# Planning Commission Staff Report

**File # 4S25 – SUB-000525-2025**

**Public Hearing and Consideration for a Subdivision Plat  
Amendment Allowing a Two-Family Lot Split for the Properties  
Located at 4719 & 4717 South Cathay Circle in Taylorsville,  
Utah.**

**From:** [Terryne Bergeson](#)  
**To:** [weston@wescoastcontracting.com](#)  
**Cc:** [Michael Williams](#)  
**Bcc:** [Jim Spung](#); [Matthew Tilly](#); [Brittany Kempff](#); [Wayne Harper](#); [Mark McGrath](#); [Ben White](#); [Steve Porten](#); [Tammy North](#); [Tom Smolka](#); [JT \(J. Taylor\)](#); [Tracy Cowdell](#); [Stephanie Shelman](#)  
**Subject:** File Review #4S25 - SSUB-000525-2025 - Two-family Lot Split Xanadu Lot 27  
**Date:** Tuesday, May 6, 2025 2:47:00 PM  
**Attachments:** [image001.png](#)  
[4S25 - DRAFT PLAT COMMENTS.pdf](#)

PRODUCT NO. 2306113  
SITE  
PLAN  
CSP.01  
3 OF 4

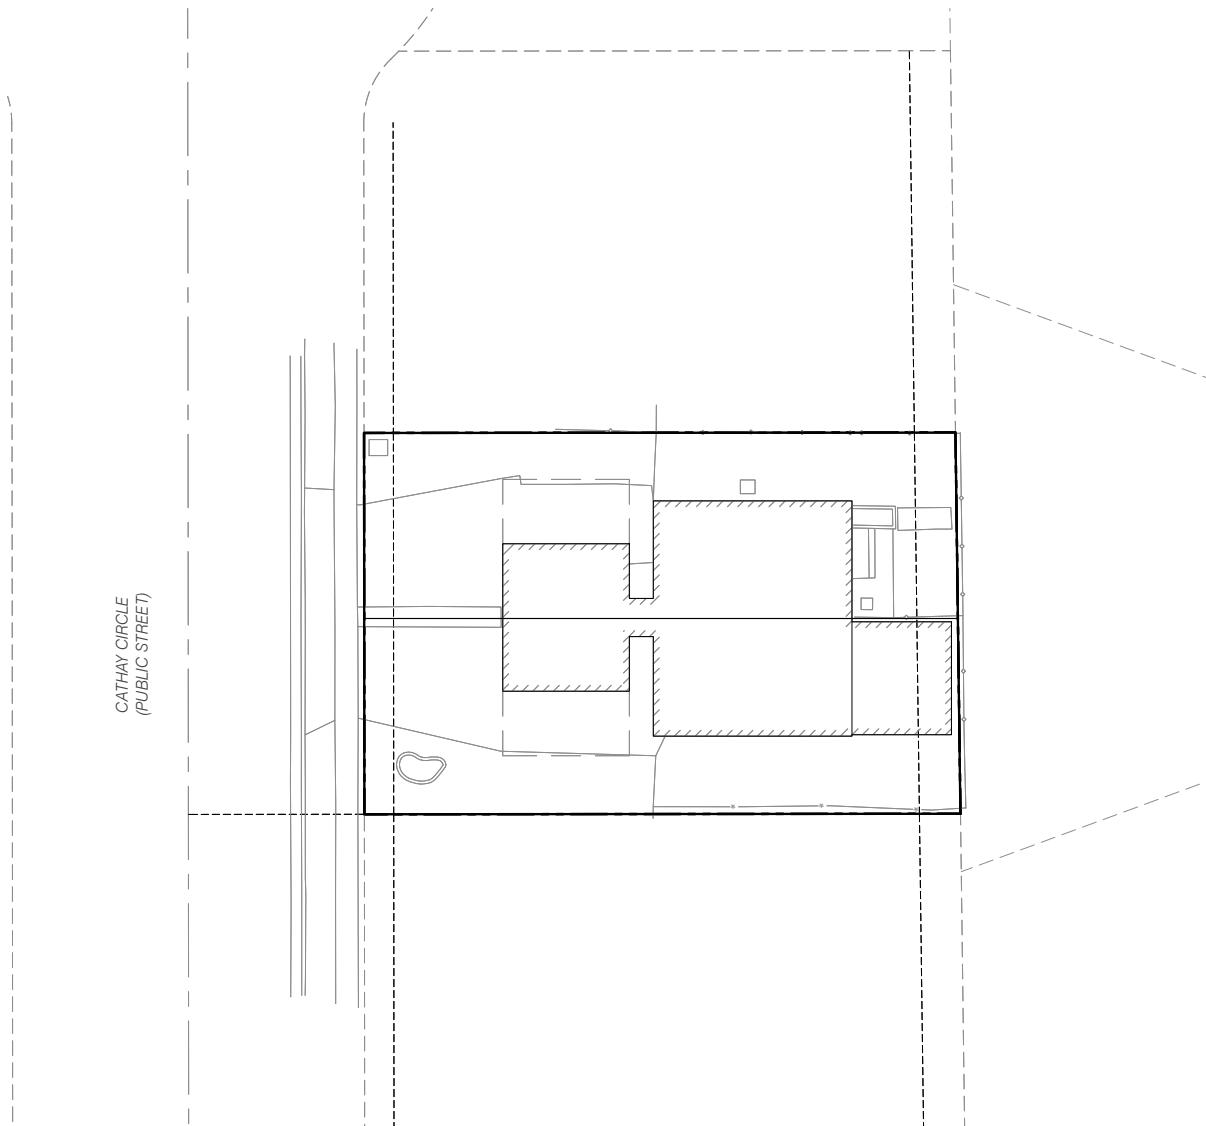
5. Site plan: Show the slope to verify that lots will not drain onto adjacent property.
6. Site plan: The structure must comply with the setbacks of the underlying zone. R-2-8 requires that covered patio structures are a minimum 5 feet from the rear property line. Please address this in the building permit by bringing the structure into compliance. Update plans to reflect the changes to the covered patio and add dimensions to the site plan that confirm compliance with this standard. (Patio and fire insulation will need to be complete with building permit closed prior to recording the final plat.)
